# MONITORING YEAR 6 ANNUAL REPORT

## CANDY CREEK MITIGATION SITE

RE: **Draft Monitoring Year 6 Report Comments  
Candy Creek Mitigation Site (DMS #96315)**  
Cape Fear River Basin 03030002, Guilford County  
Contract No. 005794

Figure 3.4 Integrated Current Condition Plan View  
Candy Creek Mitigation Site  
DMS Project No. 96315  
Monitoring Year 6 - 2022  
Guilford County, NC

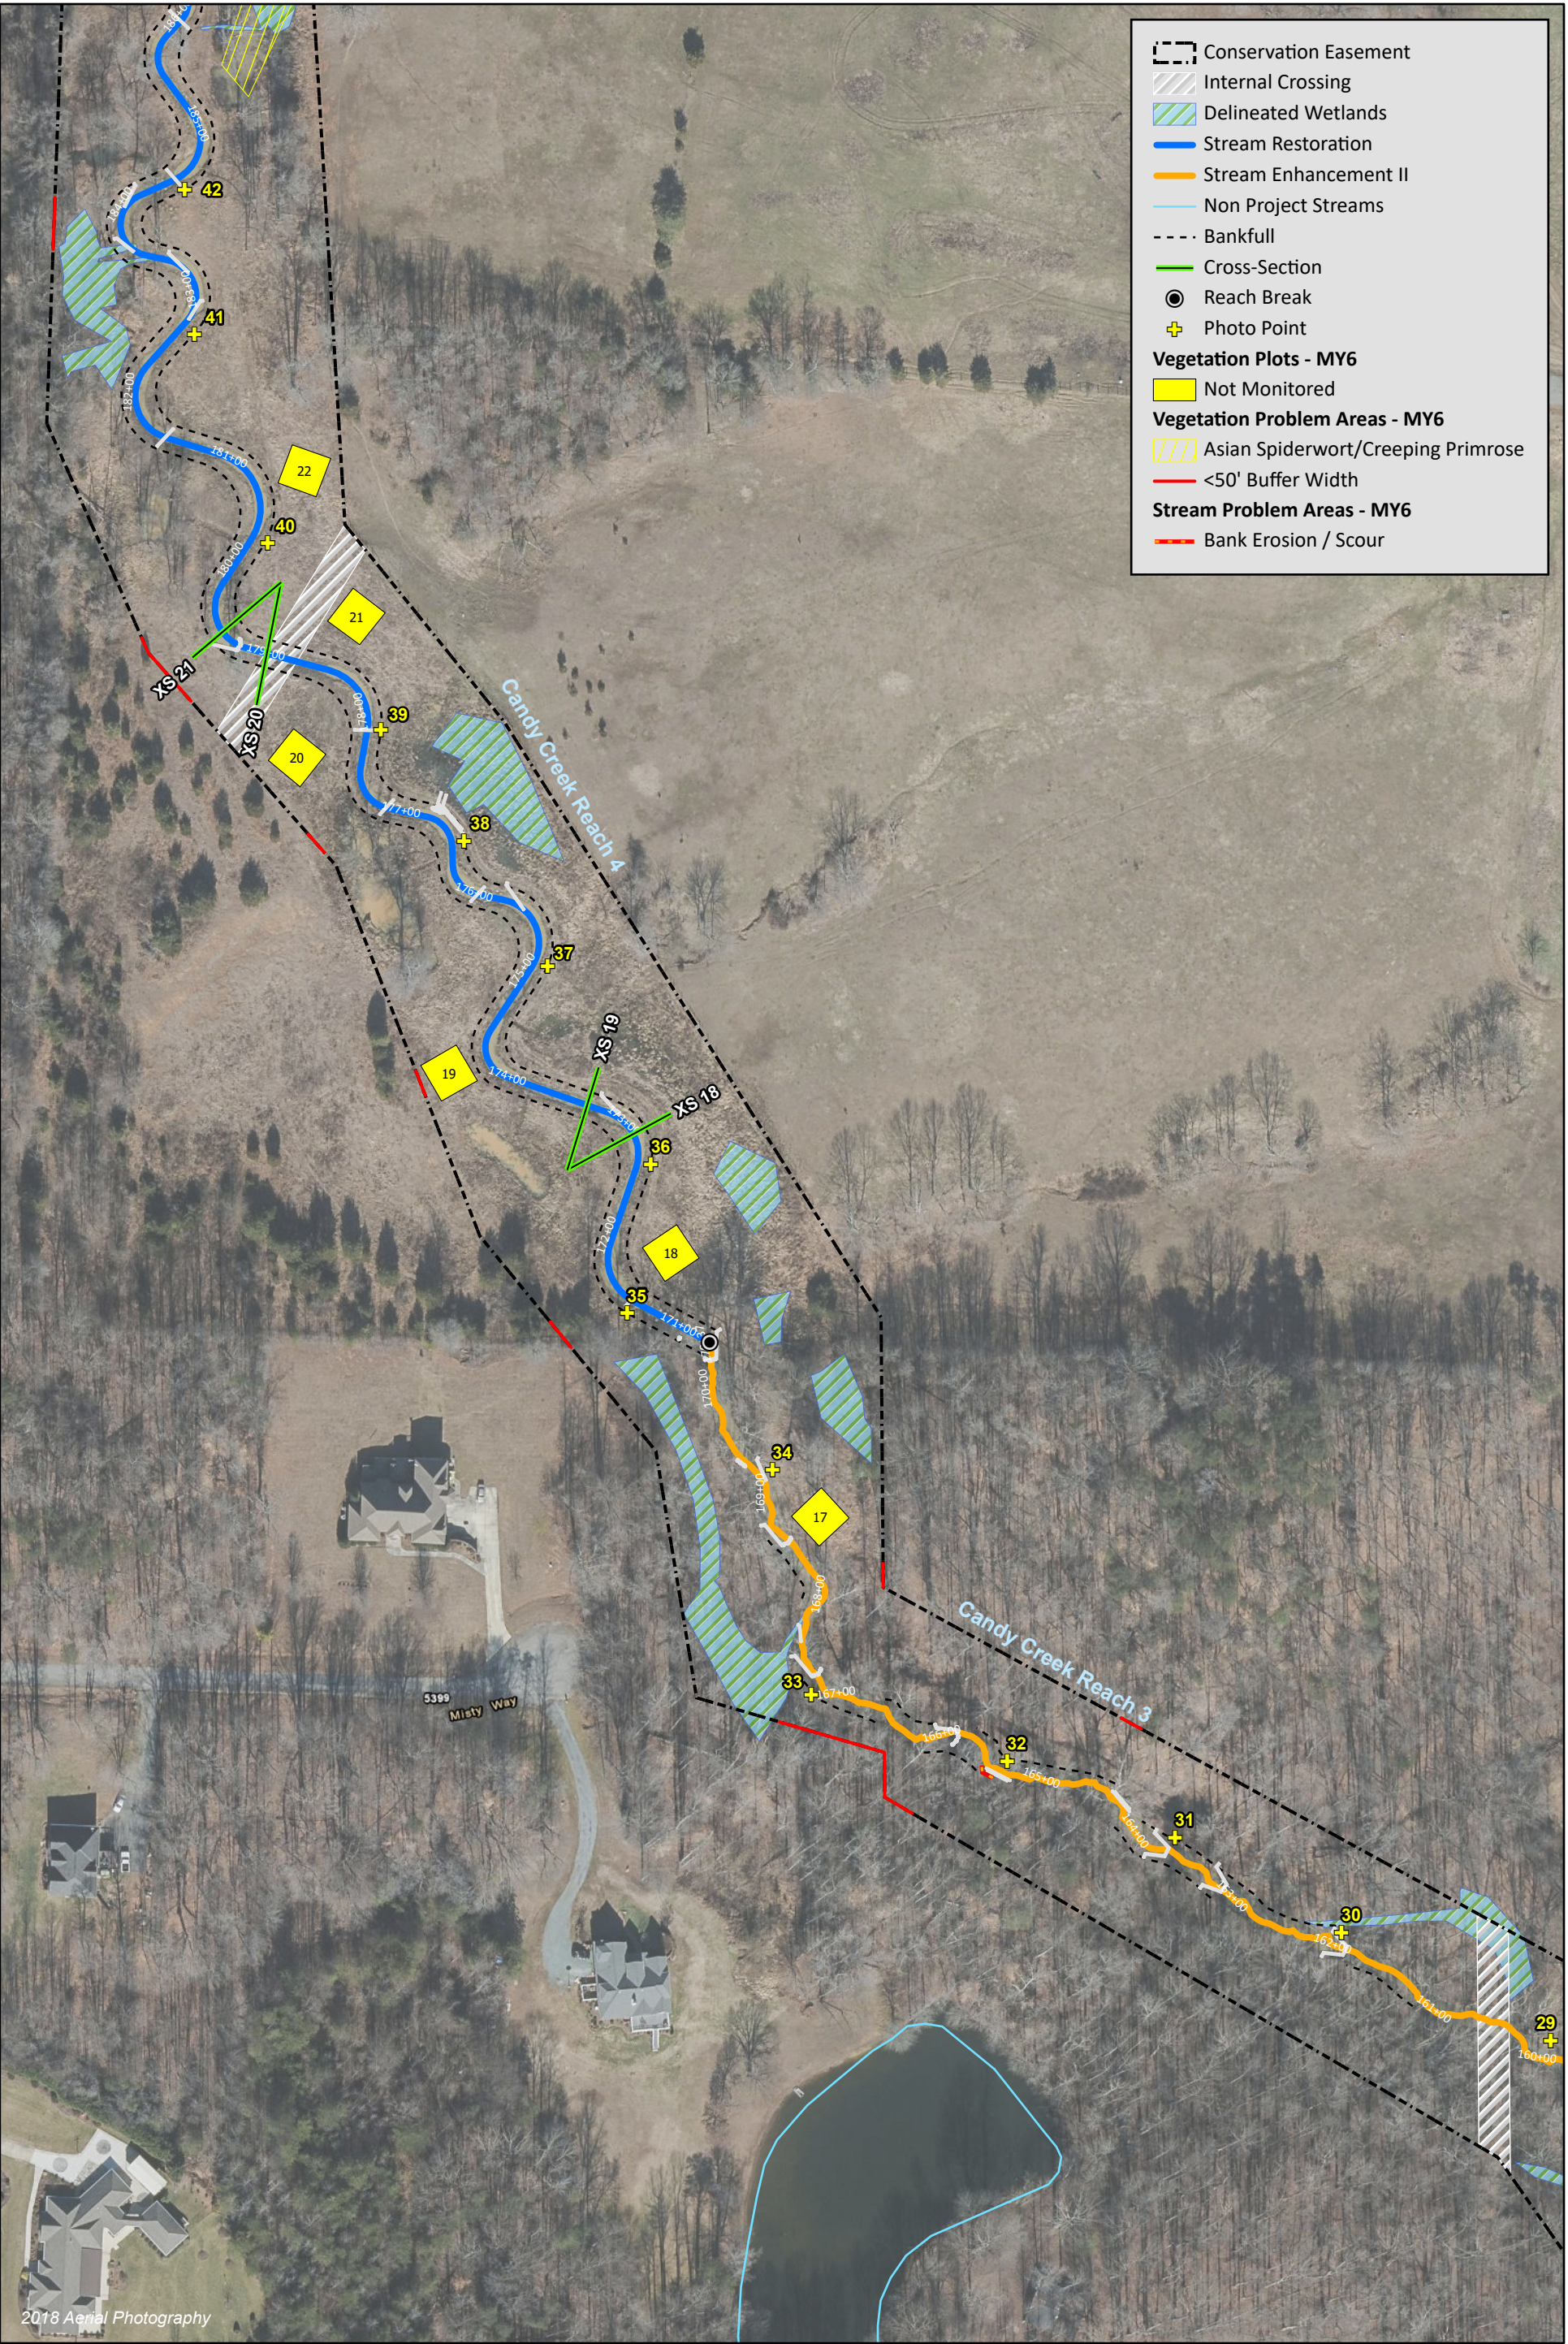
**DMS' comment: MY6 Site Walk - As discussed in the field, failing structures on EII reaches that meet the reporting threshold need to be discussed and included in the report/CCPV/tables.**

*Wildlands' response: Structural issues on EII reaches will be discussed in future reports. The structural issues on UT1C and UT1D were added to the CCPV maps.*
